## **Response to additional information request related to the submission SSC\_526**

PPs comments - 14 April 2011

In order to facilitate the consideration of the submission SSC\_526 by the SSC WG, the following clarification/information is provided by the Project Proponent (in blue):

**Figure 1 - Illustrative sketch of baseline system**

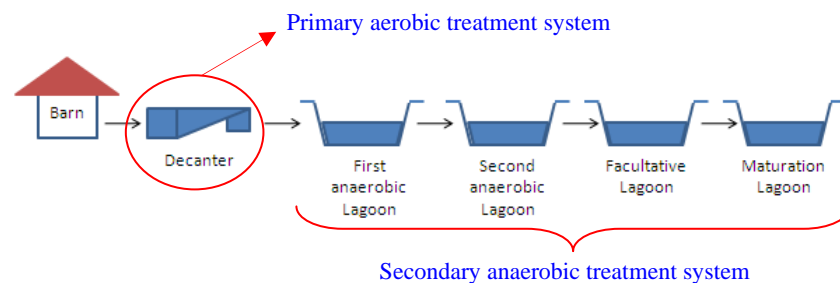
In responding question 1&2 above, an illustrative sketch of baseline and project treatment system as well as some photos showing the current treatment system would be helpful.

The solid separation occurred after the flushing. Please refer to the diagrams presented below.
